**Attachment
Review of Agency Planning Application**

City File: CDTP22-00045

Subject: **Geologic Peer Review / 30-Day Comments**
CDTP22-00045 / S. Weiss-Ishai (owner & appli.)
APN 188-150-010 / 201 Castle Hill Ranch Road
Walnut Creek Area, Contra Costa County
DMA Project 3053.22

TO: Syd Sotoodeh, Project Planner, Department of Conservation and Development
FROM: Larry Gossett, Senior Civil Engineer, Engineering Services Division
By: Joshua Laranang, Engineering Technician, Engineering Services Division
SUBJECT: **TREE PERMIT TP22-0045**
30-DAY COMMENTS – INCOMPLETE
(Weiss-Ishai/Castle Hill Ranch Road/Walnut Creek/ APN 188-150-010)
FILE: TP22-0045

Figure 4: CDTP22-00045 Landslide & Liquefaction Potential Map

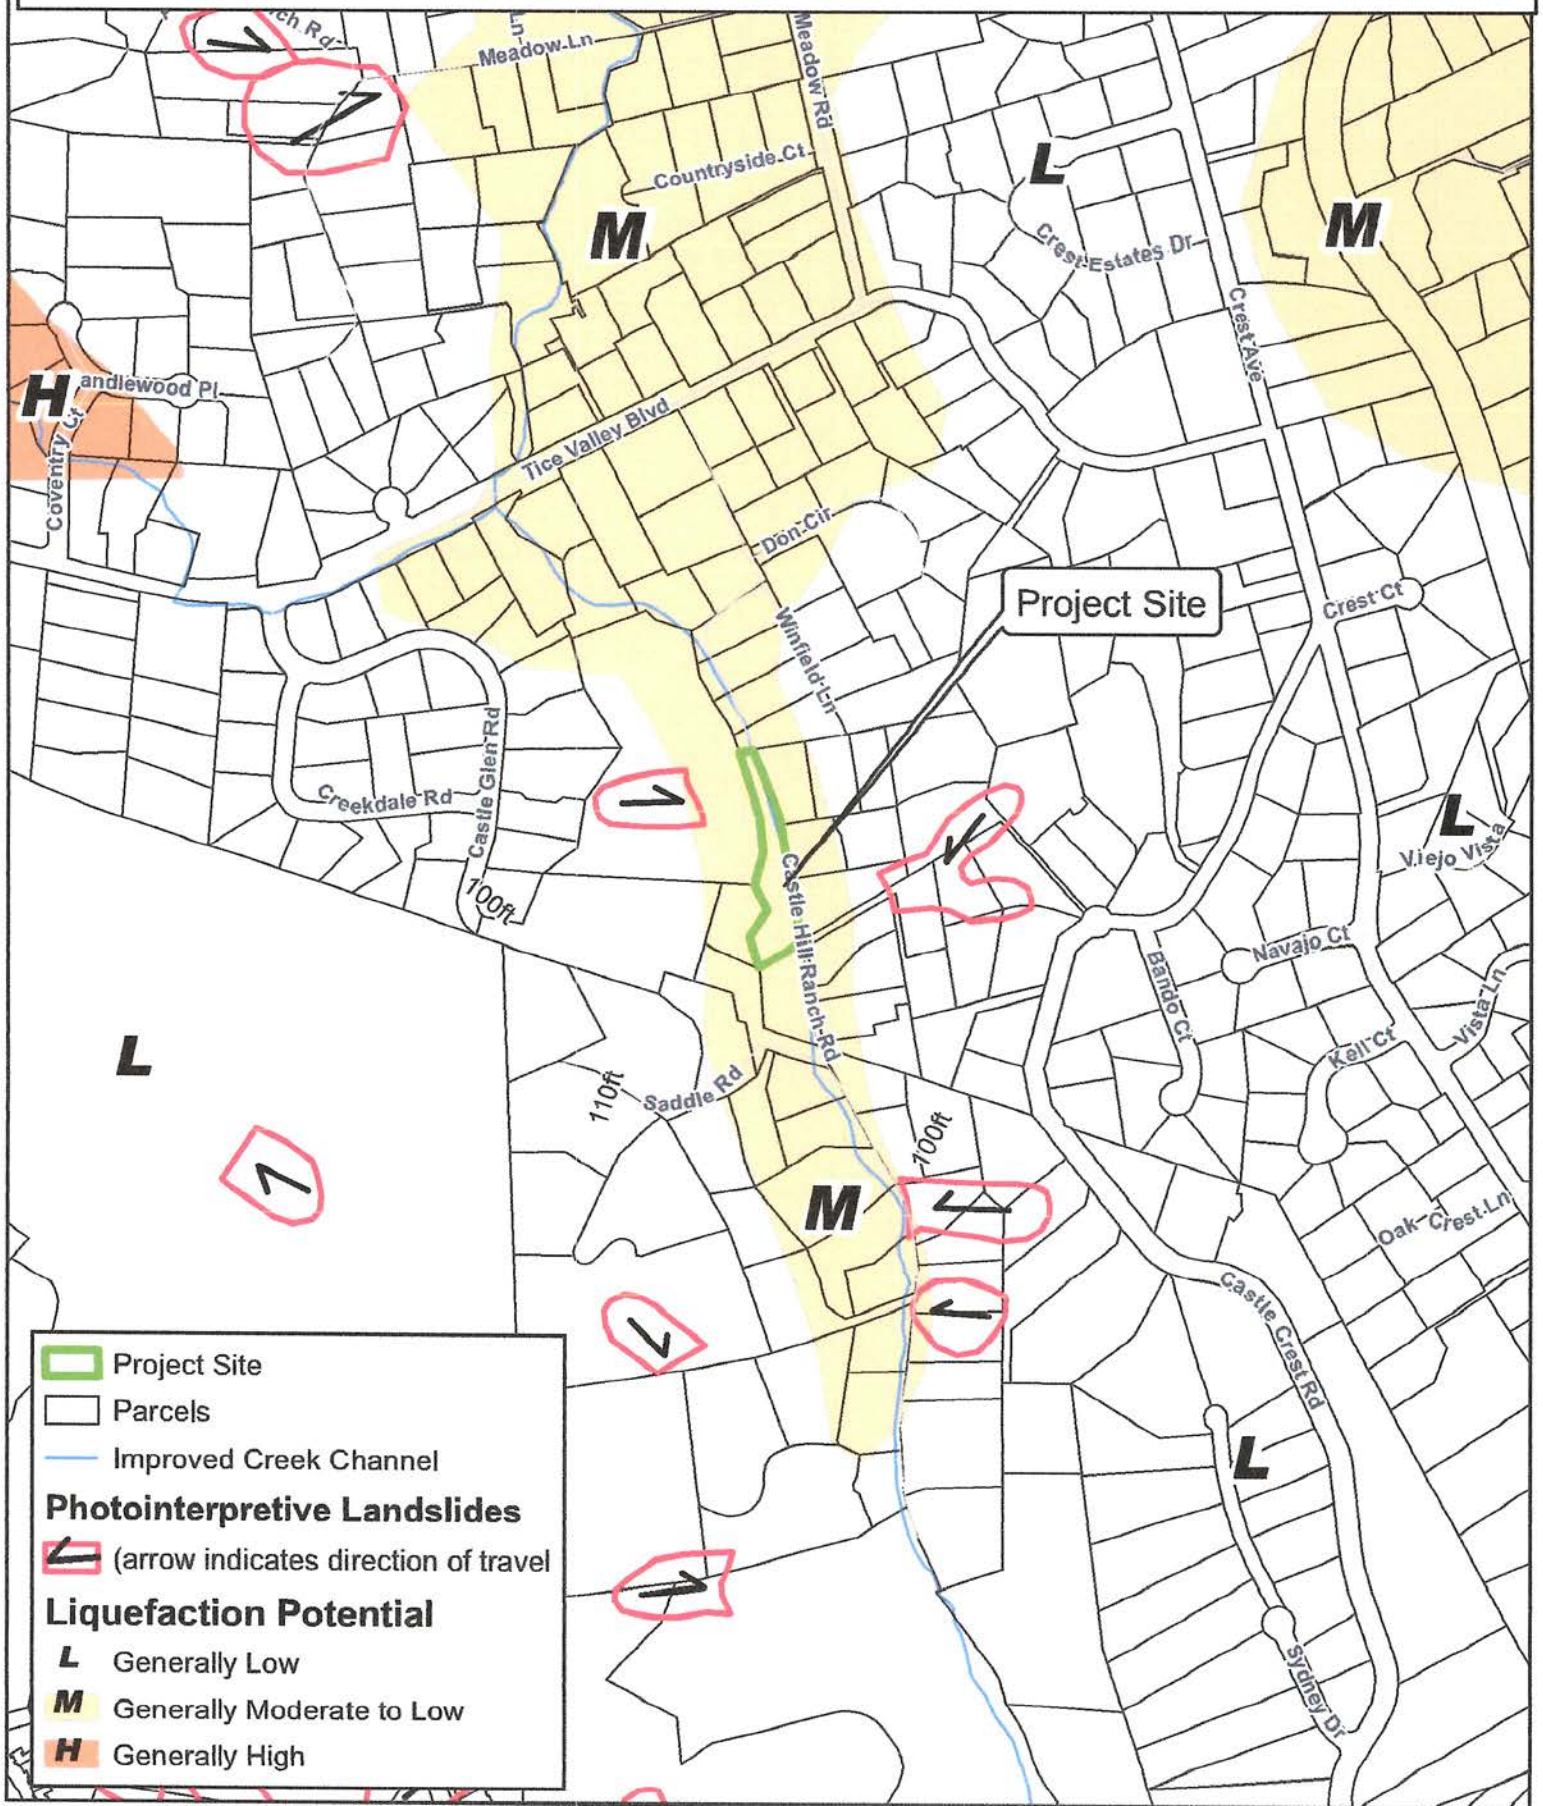
Figure 4 presents the USGS landslide map of the site and surrounding area. Landslides are outlined with a red line, and a black arrow indicates the general direction of down slope displacement. The base map for Figure 4 is a parcel map, showing the local road network, along with creeks (represented with a blue line). The boundary of the project site is outlined with a green line. No landslides were confirmed on the property by the USGS, but six (6) landslides are a mapped within the watershed of the tributary stream that defines the east boundary of the property. Based on topography and proximity of the creek channel, there is a risk of slope failure. can be considered less than significant.

It should be recognized that the classification *Generally High* liquefaction potential does not imply the presence of liquefiable sands on a parcel. The map attempts to be conservative of the side of safety. Where geologically young alluvial deposits are shown on soils maps of the County, the General Plan considers the site to be in the *Generally High* category. Site specific investigations are needed to determine if liquefiable sands are present and to provide stabilization measures where liquefiable sands are confirmed. Figure 4 indicates that the site is classified *Moderate to Low* liquefaction potential. Consequently, the map indicates the site has an unknown (but potentially significant) risk of liquefaction.
